**REMARKS / ARGUMENTS**

Application No. 10/748,755  
Amdt. dated July 18, 2007  
Reply to Office Action dated April 18, 2007

Application No. 10/748,755  
Office Action dated July 18, 2007  
Reply to Office Action dated April 18, 2007  
Annotated Sheet Showing Changes

FIG. 2

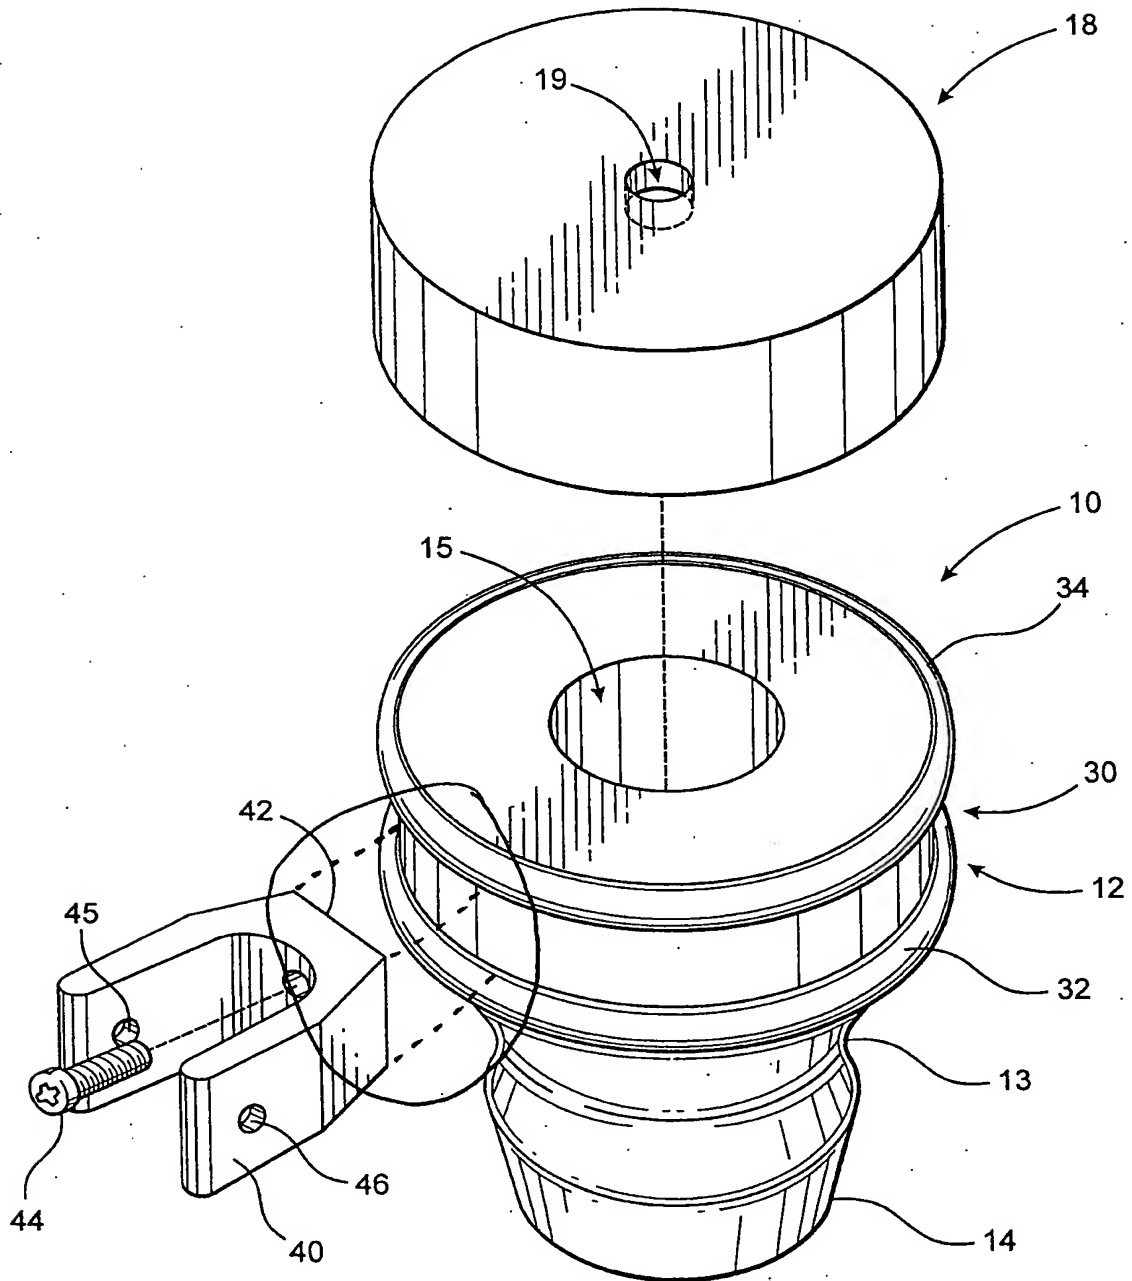
As set forth above, the PTO further objected to the drawings under 37 C.F.R. §1.84(h)(1) because of the exploded view in Fig. 2 where the separate parts within the same figure should be embraced by a bracket or a linking line in order to show the relationship or order of assembly between elements of the bracket 40 and channel 30. Accordingly, Fig. 2, as presented in the attached Replacement Sheets, has been amended herein to include a lead line to designate the relationship of the bracket 40 and the main hub member 10 and/or the channel 30 thereof.

FIG. 3B

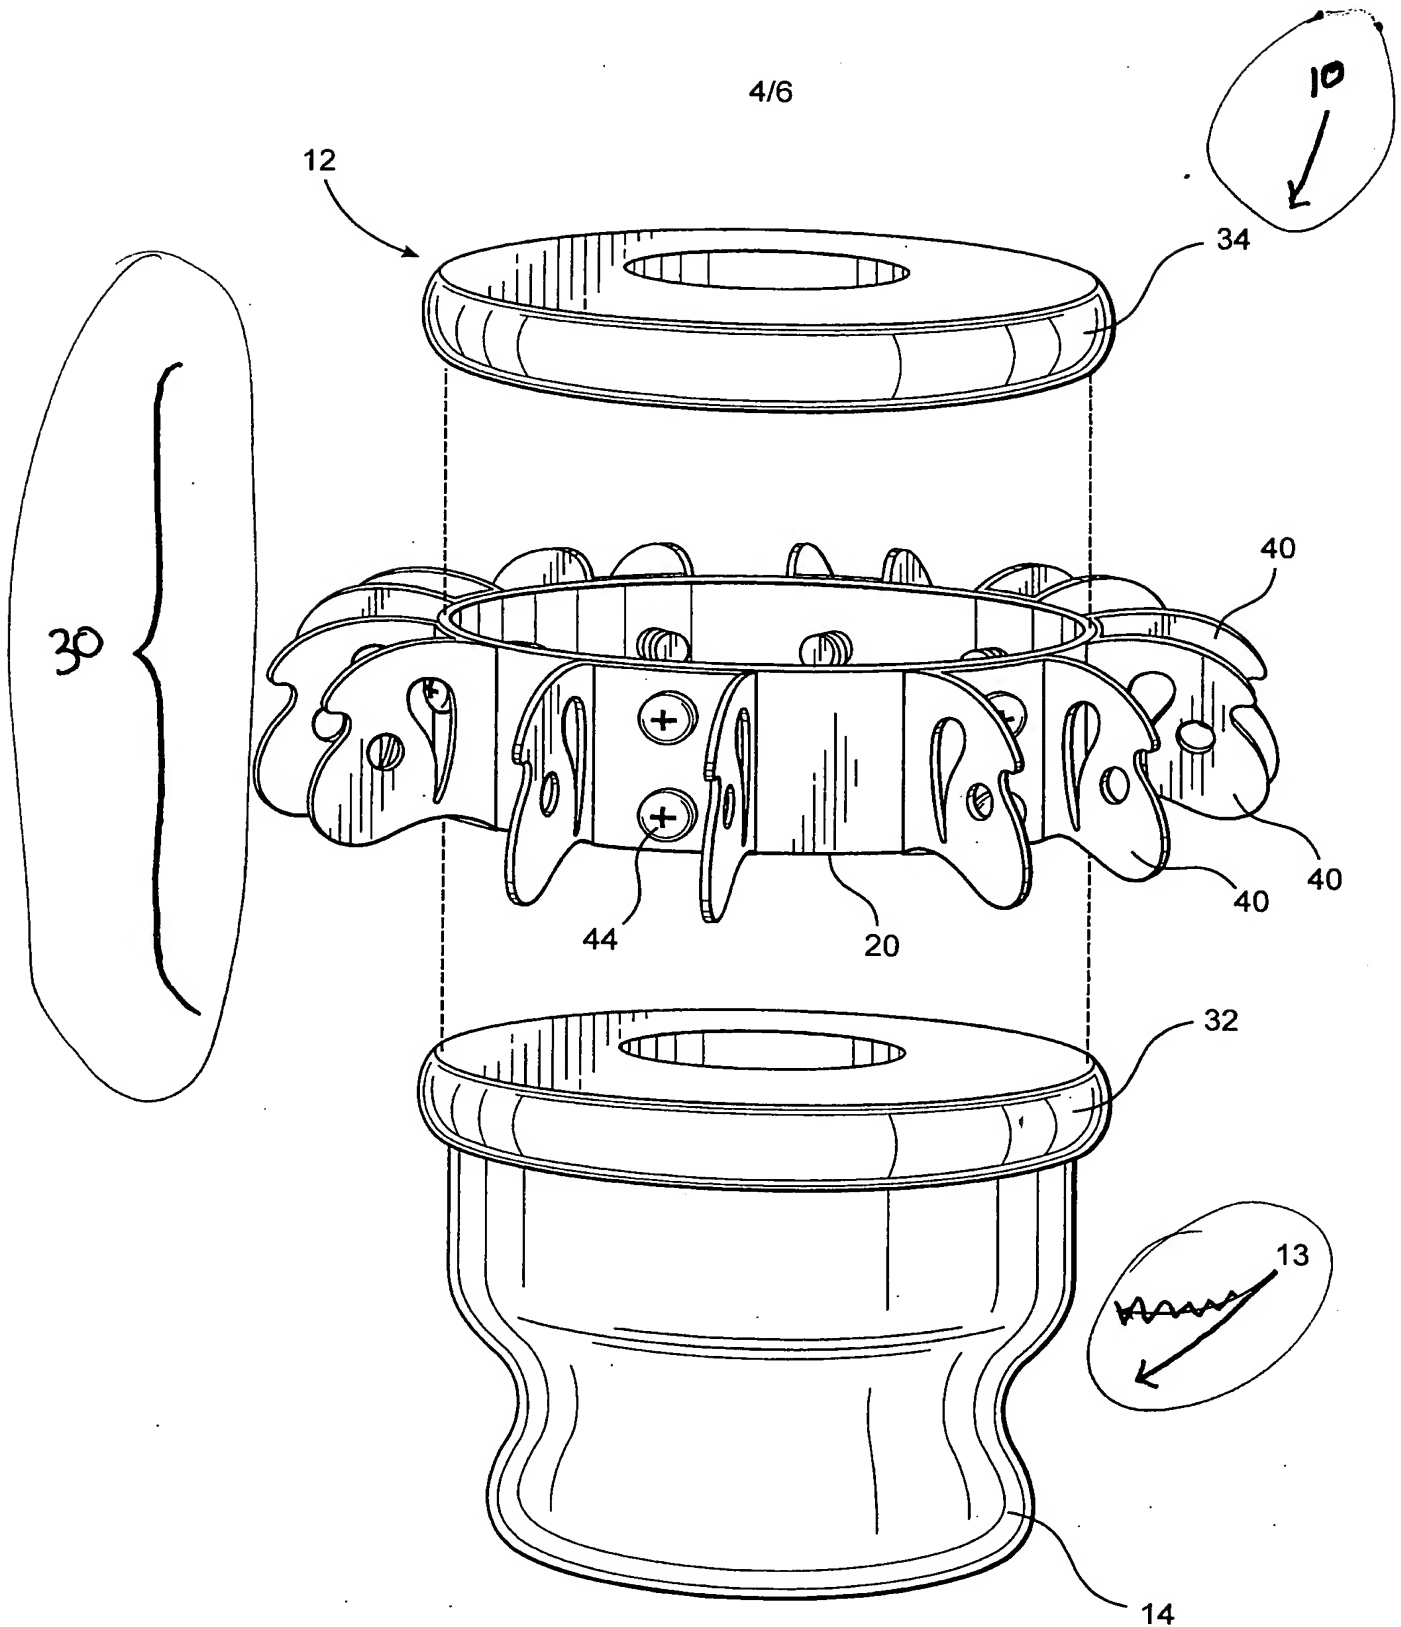
As set forth in the outstanding Office Action, the PTO objected to the drawings as failing to comply with 37 C.F.R. §1.83(a) because Figure 3B fails to show the split/separated main hub member including "both the waist 13 and a channel 30," the channel 30 being positioned between the top and bottom ledges 32, 34 as described in Applicant's specification. Accordingly, Figure 3B, as presented in the attached Replacement Sheets, has been amended herein to include reference character 30, illustrating the channel being disposed between upper portion 12 and lower portion 14. In addition, Figure 3B, as presented in the attached Replacement Sheets has been amended to further include reference character 10, illustrating the hub member as shown therein. Furthermore, as also presented in the attached Replacement Sheets, Figure 3B has also been amended herein to more accurately reference the waist 13.
